**FINAL  
MY1 (2022) MONITORING REPORT**

**LAUREL SPRINGS STREAM AND WETLAND MITIGATION SITE**

## **Response to DMS Comments – Monitoring Year 1 (2022)**

Laurel Springs Stream and Wetland Mitigation Site

Figure 1. Current Conditions Plan View

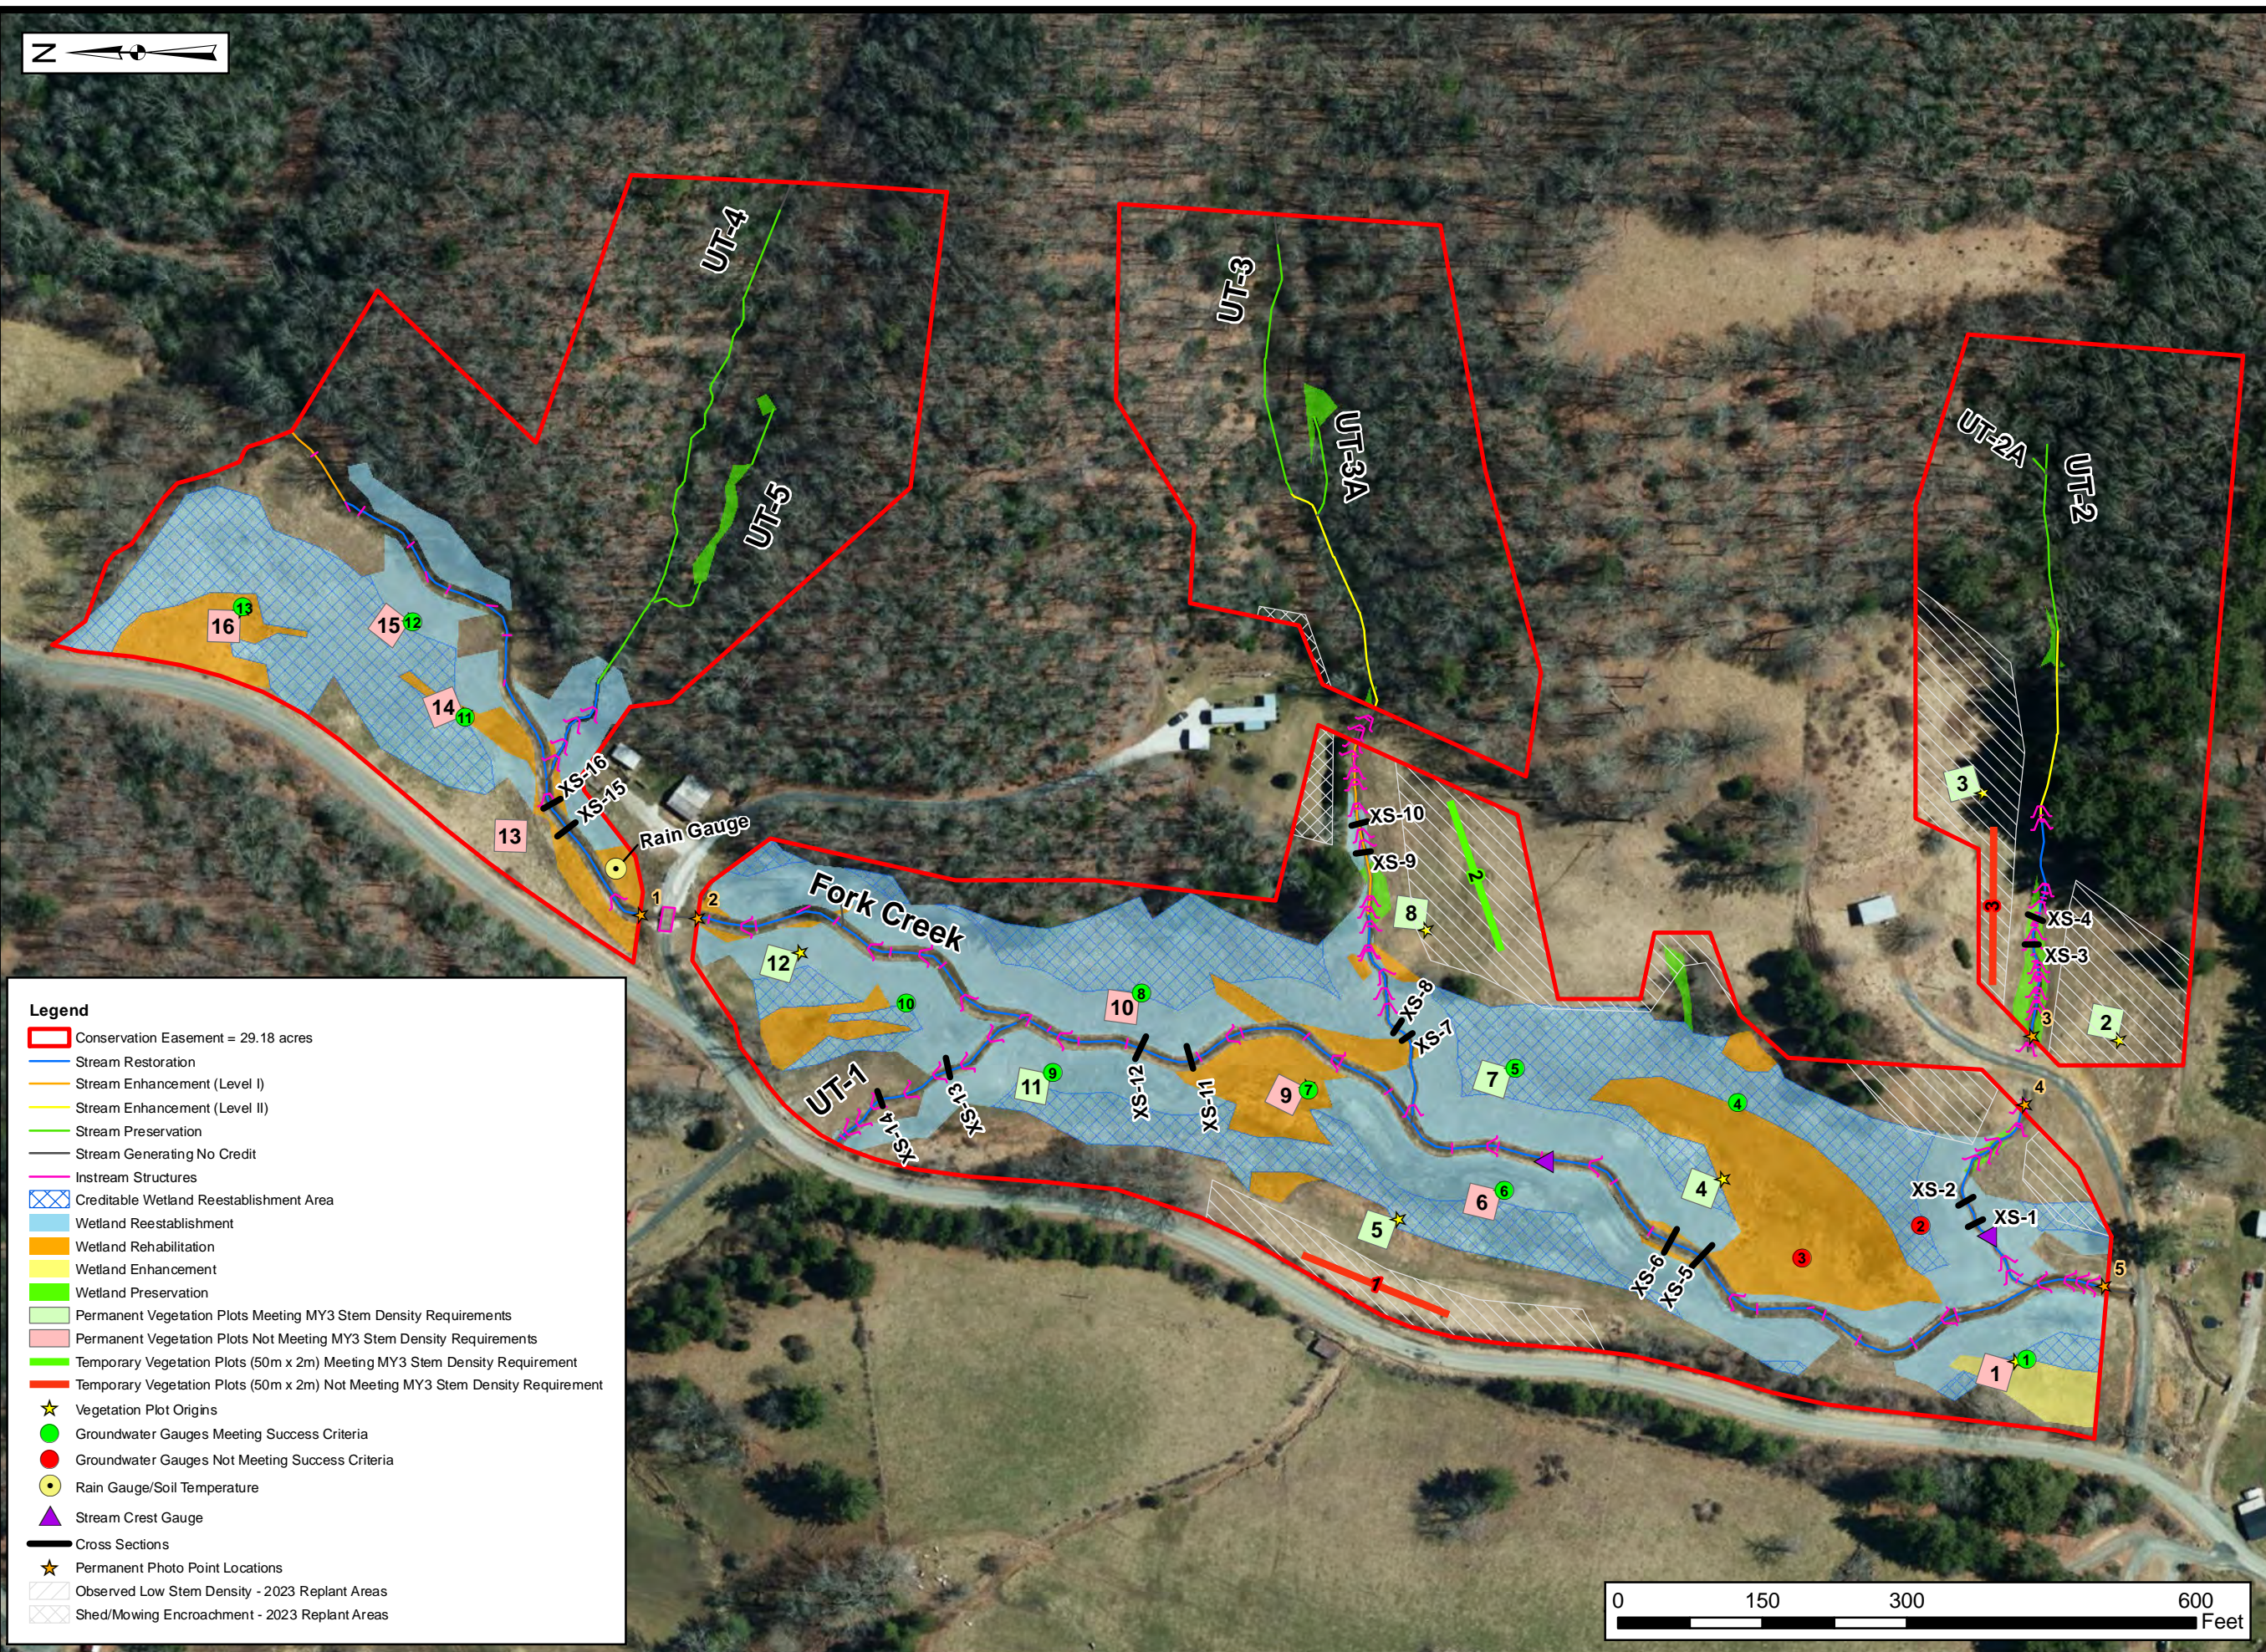
3. When comparing the MY0 CCPV (Figure 1) to the updated Monitoring Map (Figure 9) provided on August 26, 2021, some of the veg plots and groundwater gauge locations appear to be flipped and are no longer located in creditable wetland reestablishment areas (GWG 1, 6, & 9). While it's beneficial to have some groundwater gauges located in non-credited wetlands, please ensure creditable wetland reestablishment areas have adequate monitoring wells to document hydrologic uplift.

Response: During the 2022/2023 dormant season, RS plans to move gauges 6, 9, 11, and 12 into creditable wetland reestablishment areas. Also, gauge 1 will be moved into the wetland enhancement area, as depicted in Figure 9 of the approved Mitigation Plan. Please advise if the IRT would like additional changes to the locations of monitoring features.

Figure 2. Asset Map

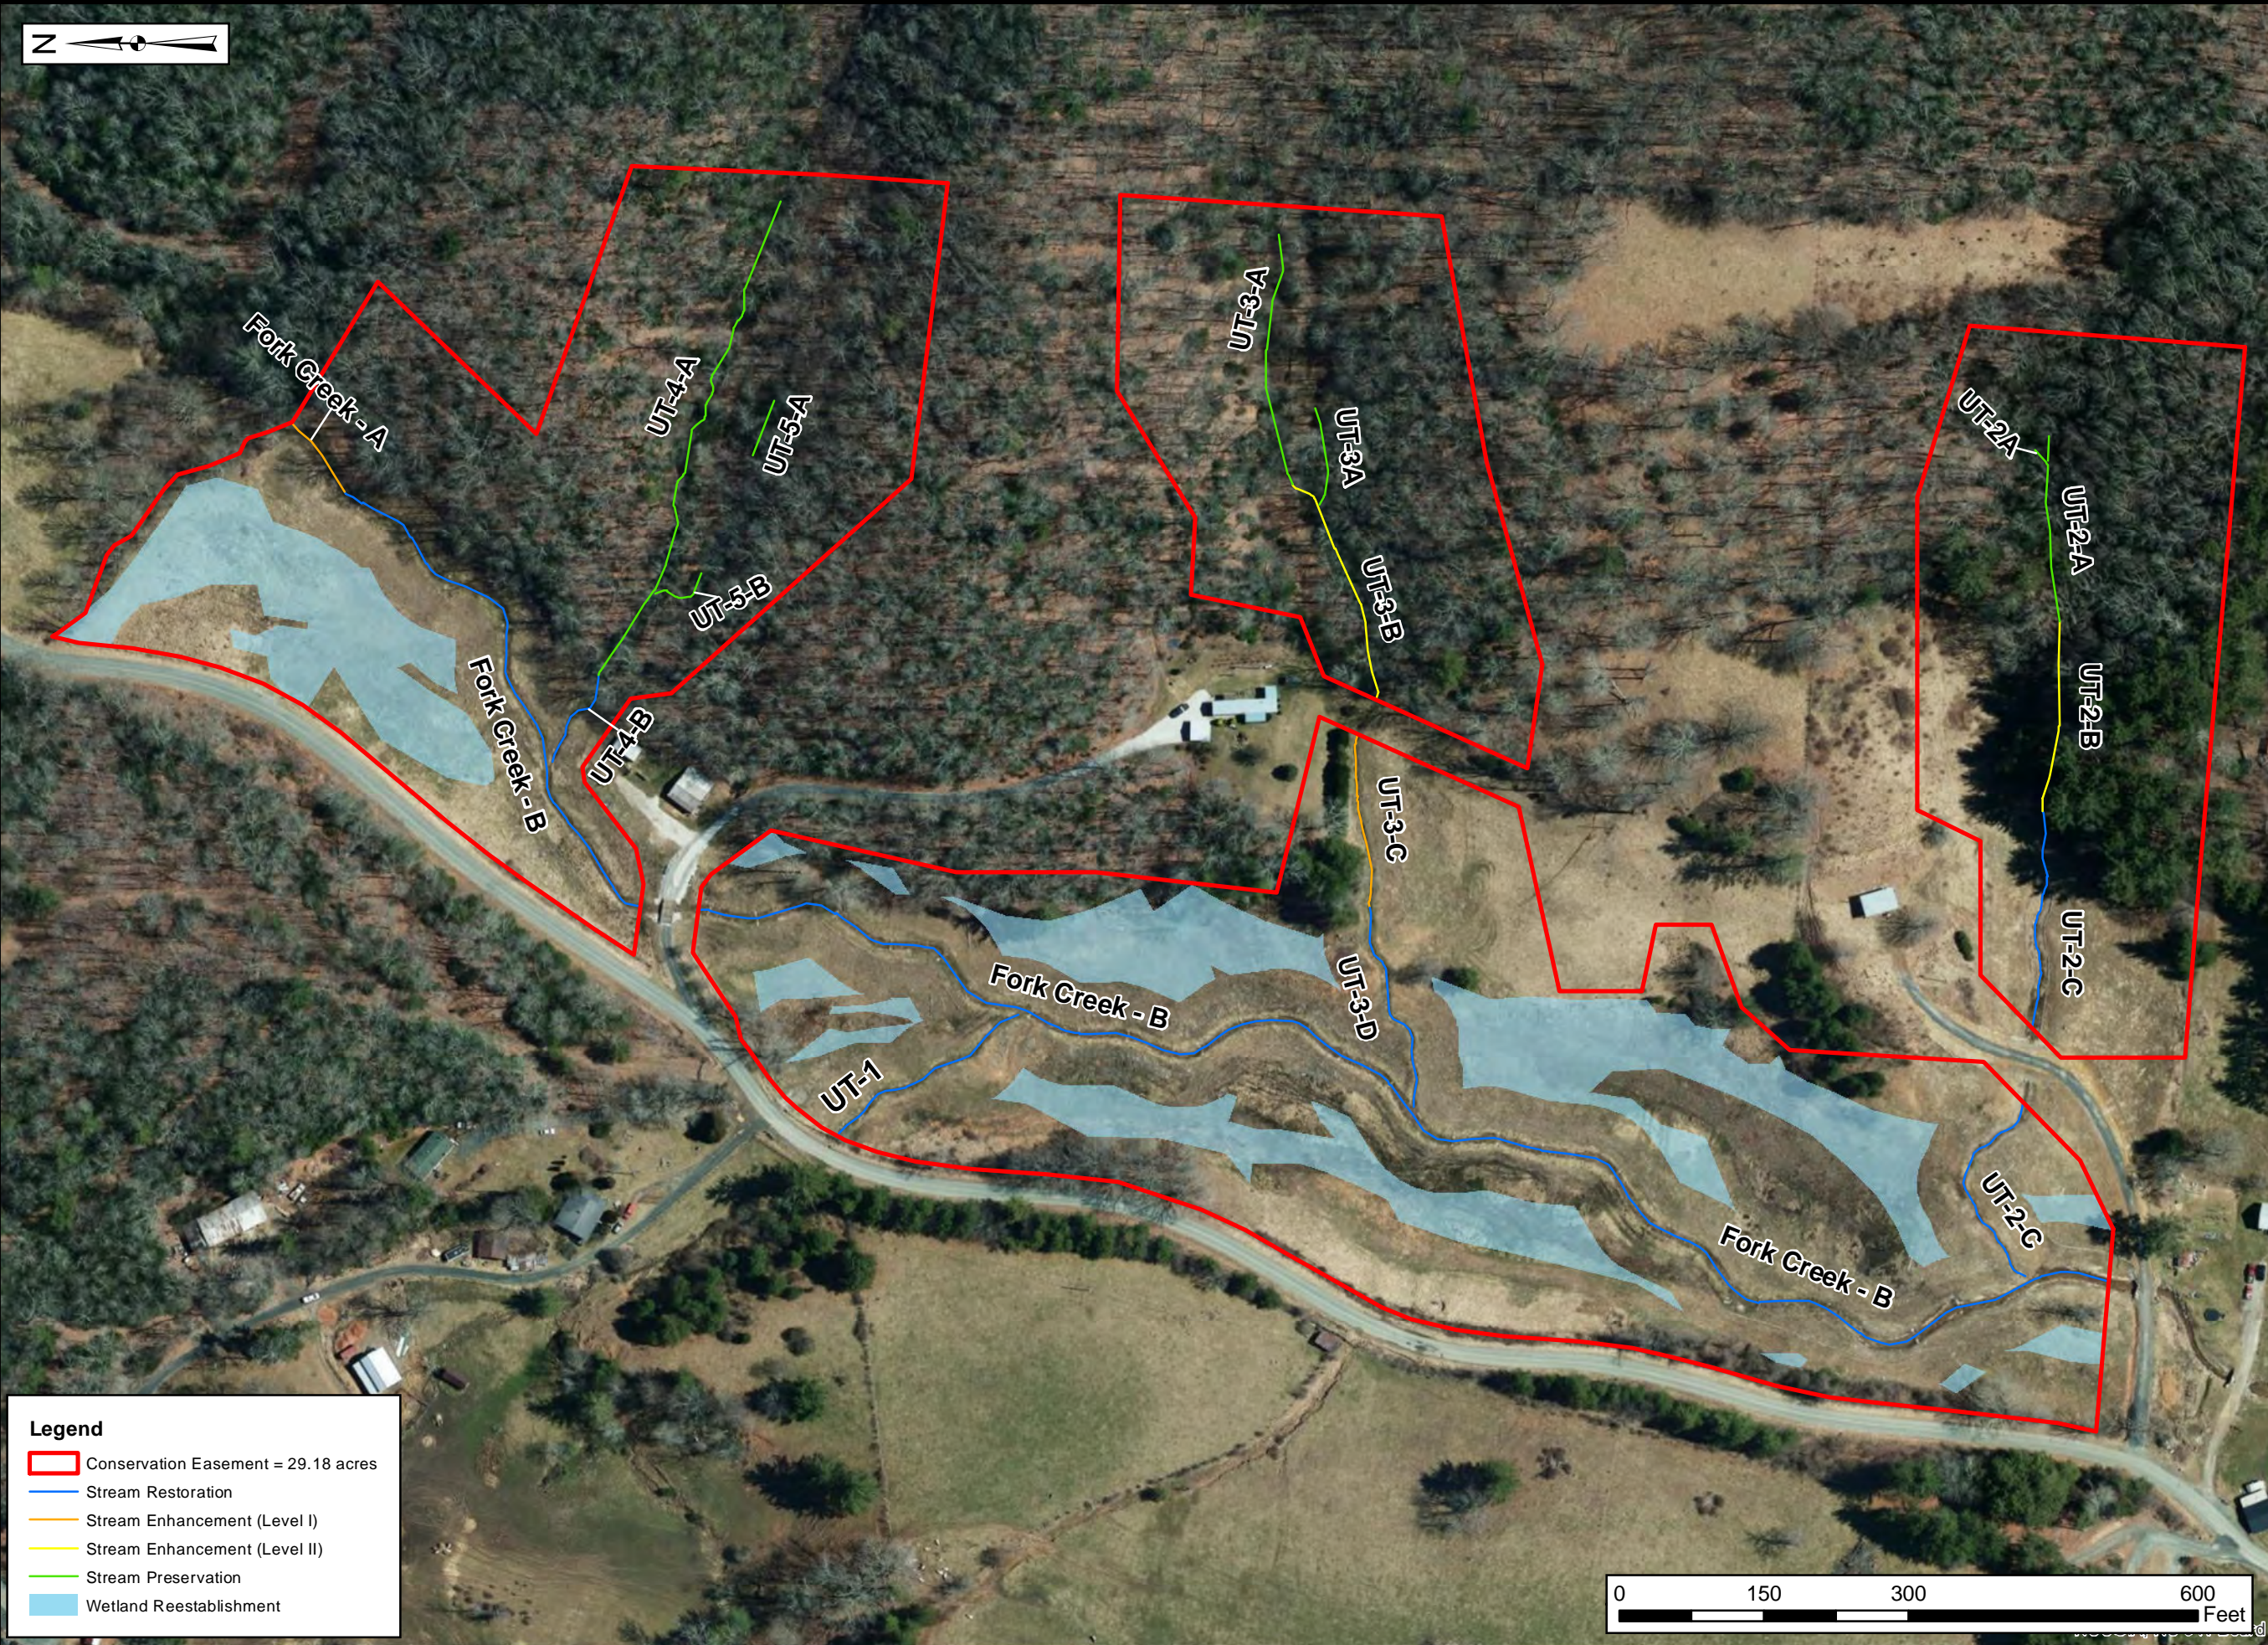
3. Appendix A: Visual Assessment Data: Please provide an additional single page georeferenced “Asset Map” in the appendix that clearly identifies the project reaches, approaches and creditable wetland areas as specified in Table 1. Please only include the creditable reaches and wetlands in the project asset map.

**Response:** Figure 2 “Asset Map” was added to Appendix A. This map depicts only creditable stream reaches and wetland areas.

# Laurel Springs Fork Creek Grest Gauge (2022 Data)

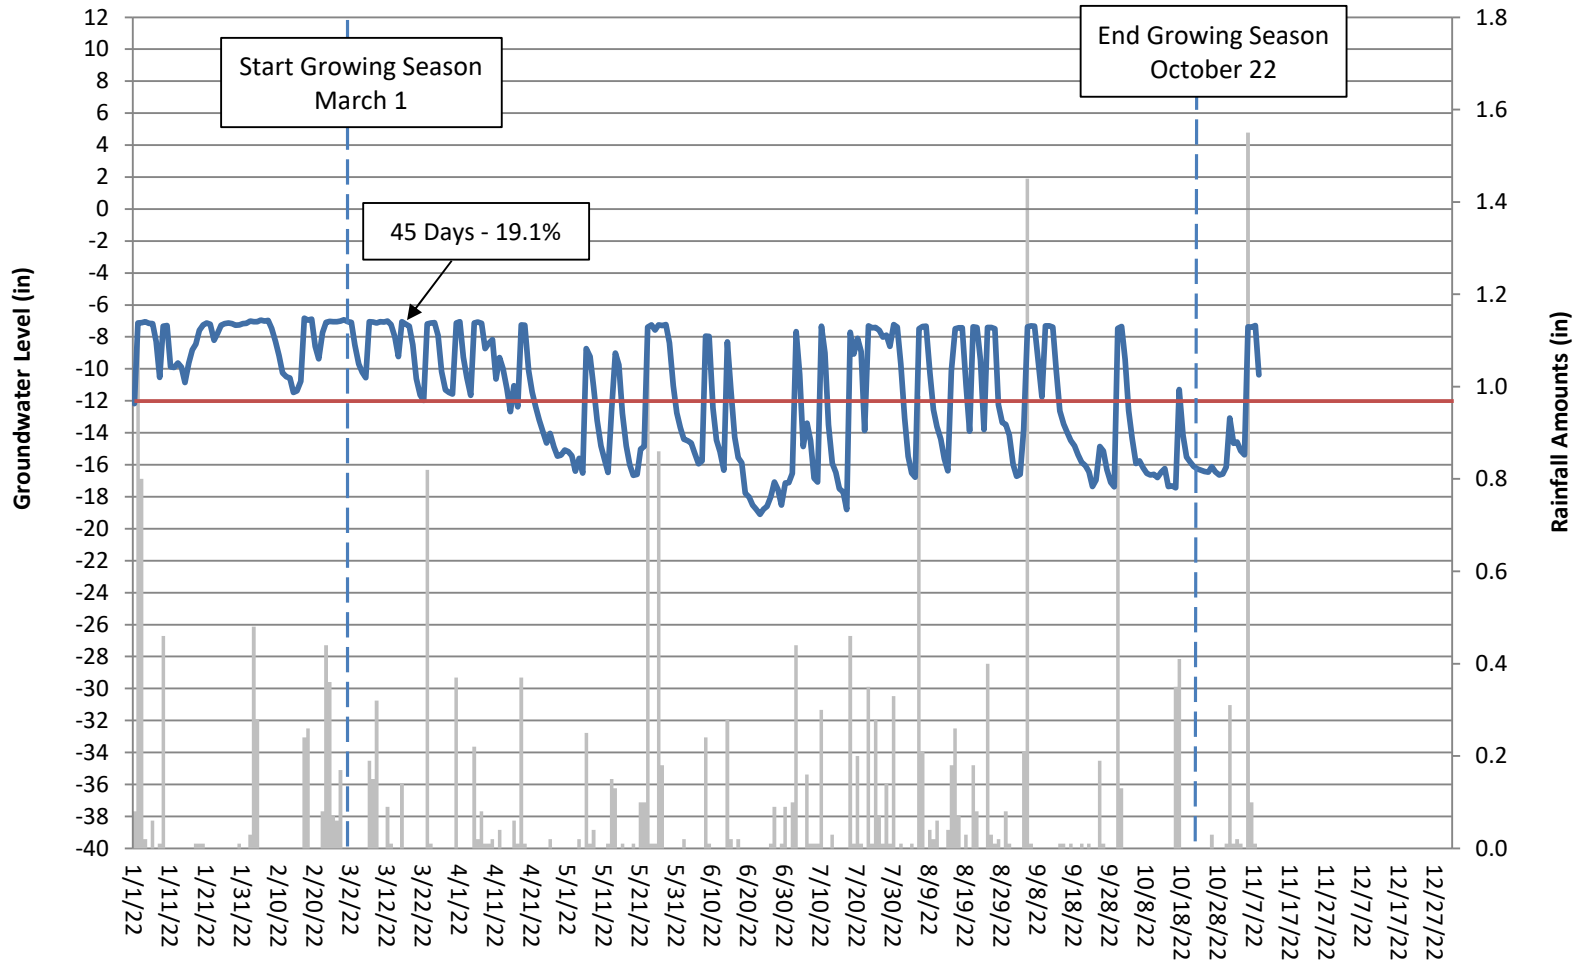
8. Appendix D - Hydrologic Data: Are the stream crest gauges manual or automated? If automated, please provide the graph for the three bankfull events reported. Please report the bankfull events for each gauge separately in Table 11-Verification of Bankfull Events and include a column that indicates the applicable monitoring year.

Response: Fork Creek has an automated crest gauge installed. A graph with this crest gauge data has been included in Appendix D. The gauge on UT-2 is being used to monitor continuous stream flow, and no bankfull events were captured with it during MY1. Table 11 has been revised to clarify.

# Laurel Springs UT2 Stream Flow (2022 Data)

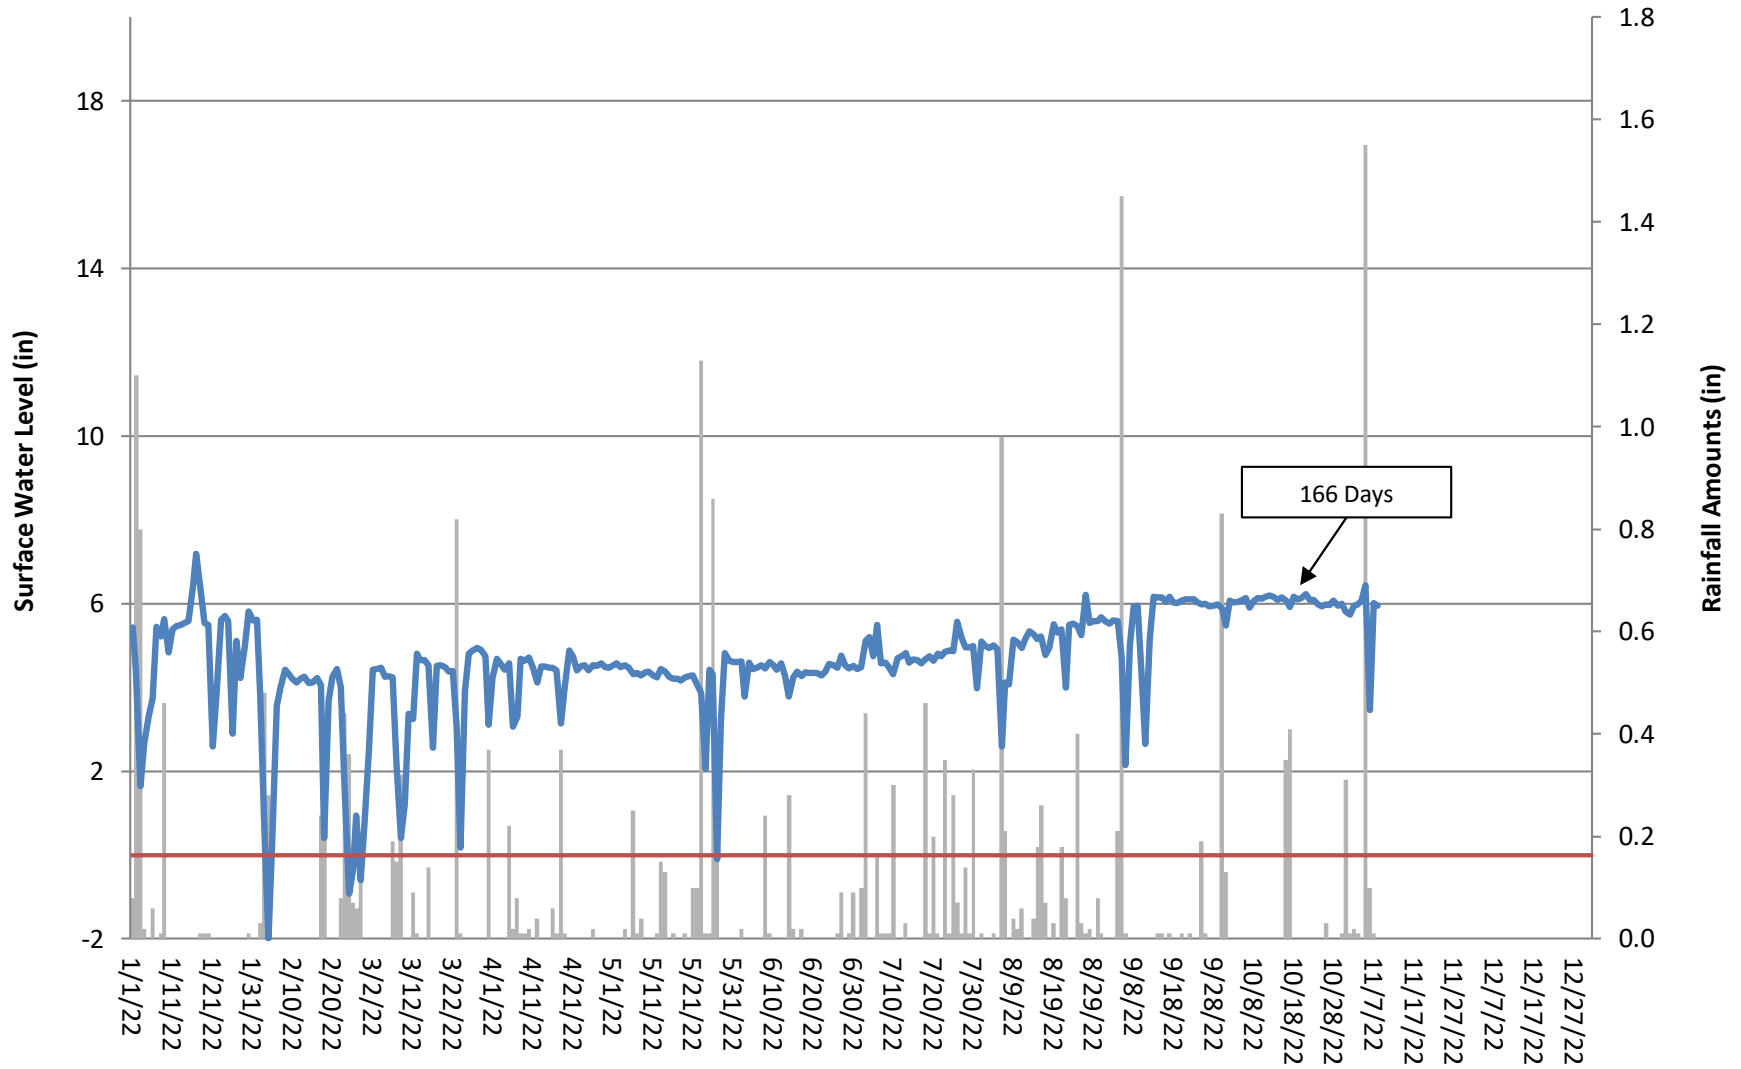
9. Appendix D - Hydrologic Data: Please discuss the UT2 stream flow results in the report summary and report text.  
Response: A brief discussion of UT 2 stream flow results was added to the report summary and Section 3.1 Stream Assessment.
